SITE 5  
NEWBURY (WELLS RIVER), EXIT #17, I-91

STATEWIDE IM LITE (6)

TRAFFIC SHEET NO. 7 OF 37 SHEETS

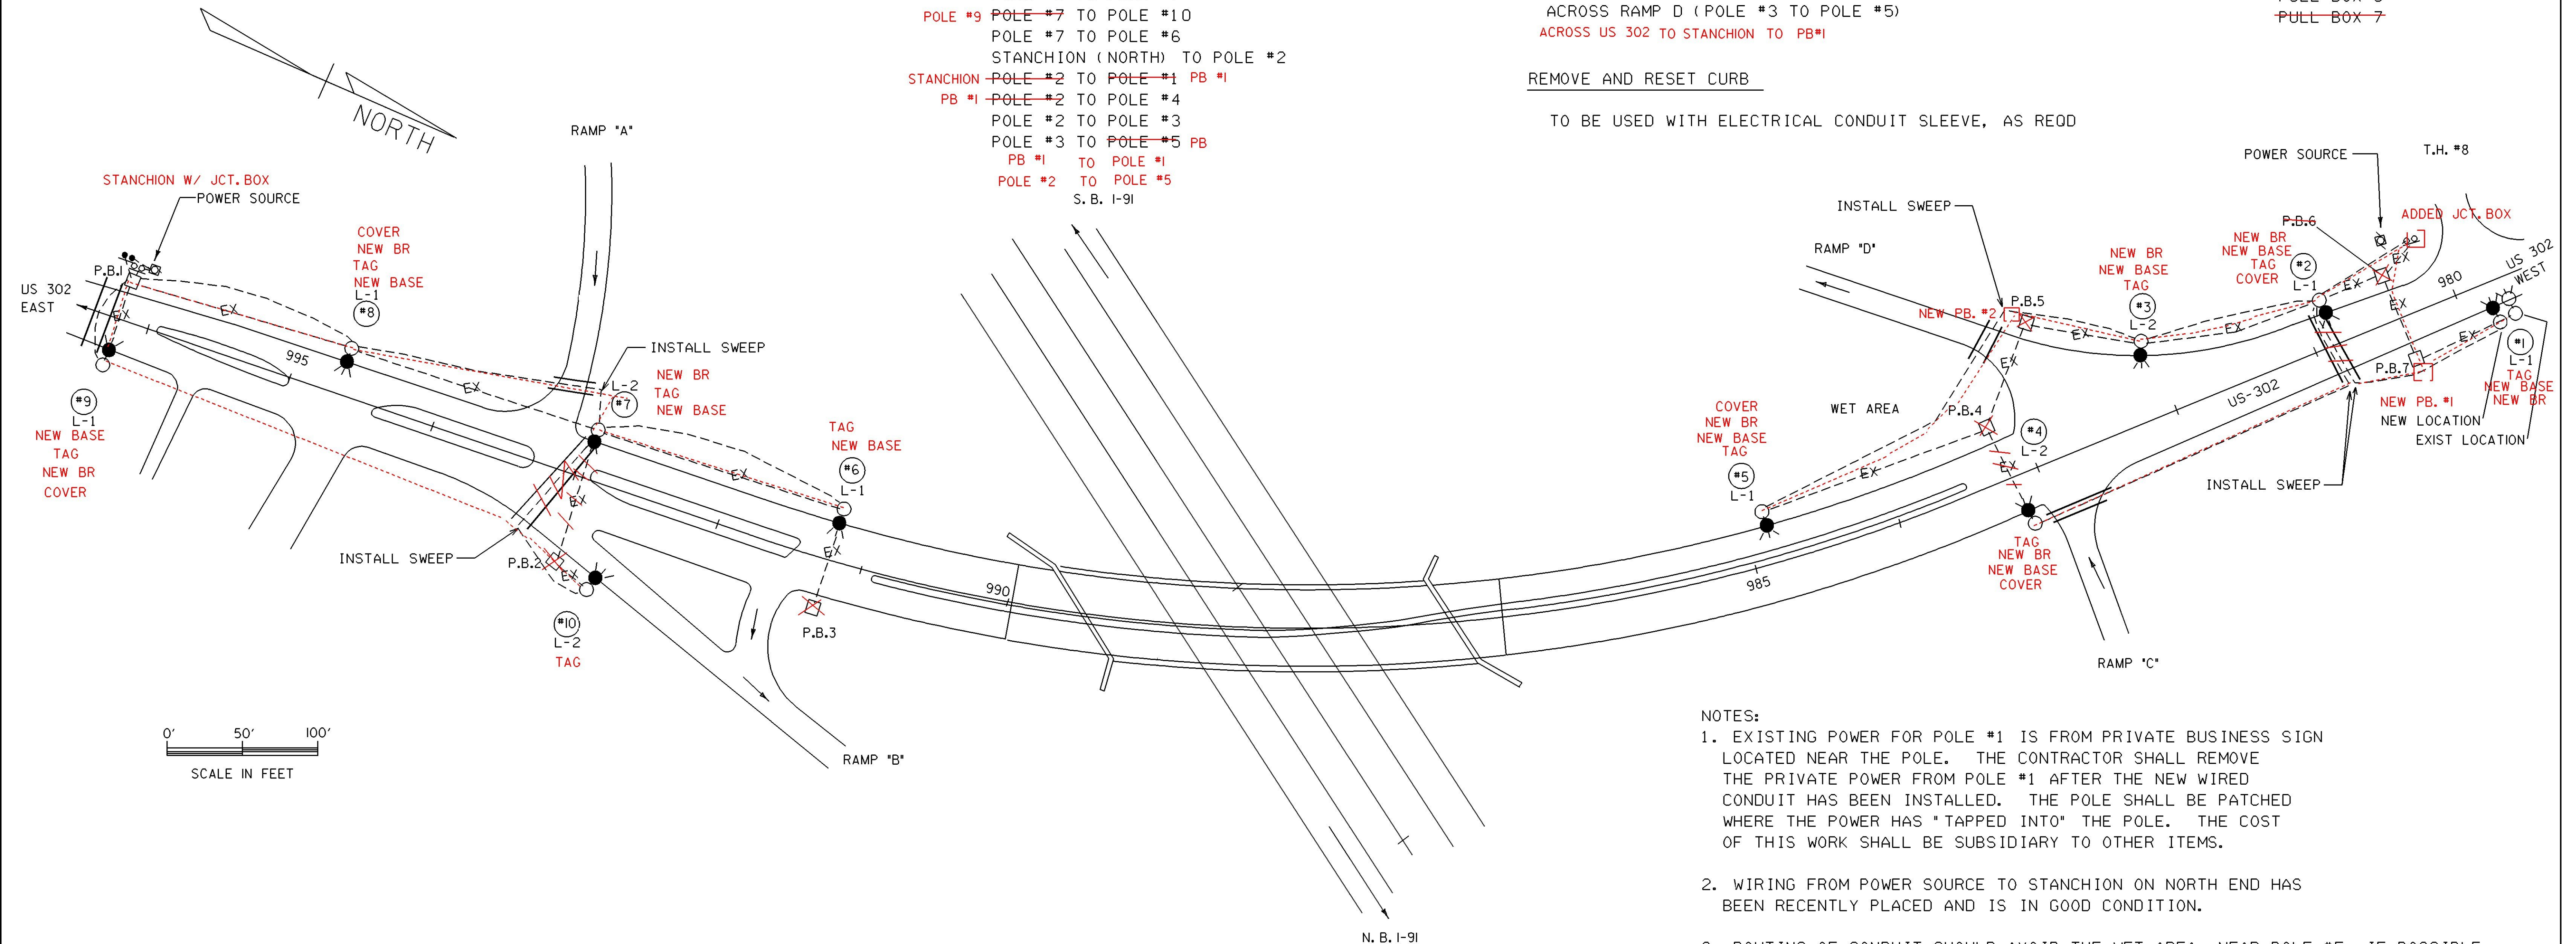
STANCHION  
ACROSS US 302 (PULL BOX 1 TO POLE #9)  
ACROSS RAMP A (POLE #8 TO POLE #7)  
ACROSS US 302 (POLE #7 TO POLE #10)  
~~ACROSS US 302 (POLE #2 TO POLE #1 AND POLE #2 TO POLE #4)~~  
ACROSS RAMP C (POLE #2 TO POLE #4)  
ACROSS RAMP D (POLE #3 TO POLE #5)  
ACROSS US 302 TO STANCHION TO PB#1

~~PULL BOX 2~~  
✓ PULL BOX 3  
✓ PULL BOX 4  
✓ PULL BOX 5  
✓ PULL BOX 6  
~~PULL BOX 7~~

679.23	679.21 MOD 3	679.21 MOD 2	679.50 MOD	679.25	678.24	679.50	679.25 MOD				679.21 MOD 1	
1	X ✓	X ✓			X ✓	X ✓	X ✓		COUP	150 W. HPS	30	X ✓	NEW BASE TO BE POURED 15 FT SOUTH (EAST) OF EXISTING.
2	X ✓	X ✓	X ✓		X ✓	X ✓	X ✓		NONE	150 W. HPS	30	X ✓	NEW BASE ELEV. TO BE APPROX. 10" HIGHER THAN EXISTING
3	X ✓	X ✓			X ✓	X ✓	X ✓		NONE	150 W. HPS	30	X ✓	NEW BASE ELEV. TO BE APPROX. 8" HIGHER THAN EXISTING
4	X ✓	X ✓	X ✓		X ✓	X ✓	X ✓		NONE	150 W. HPS	30	X ✓	NEW BASE ELEV. TO BE APPROX. 8" HIGHER THAN EXISTING
5	X ✓	X ✓	X ✓		X ✓	X ✓	X ✓		NONE	150 W. HPS	30	X ✓	NEW BASE ELEV. TO BE APPROX. 6" HIGHER THAN EXISTING
6		X ✓			X ✓	X ✓	X ✓		NONE	150 W. HPS	30	X ✓	NEW BASE ELEV. TO BE APPROX. 6" HIGHER THAN EXISTING
7	X ✓	X ✓			X ✓	X ✓	X ✓		NONE	150 W. HPS	30	X ✓	NEW BASE ELEV. TO BE APPROX. 6" HIGHER THAN EXISTING
8	X ✓	X ✓	X ✓		X ✓	X ✓	X ✓		NONE	150 W. HPS	30	X ✓	NEW BASE ELEV. TO BE APPROX. 6" HIGHER THAN EXISTING
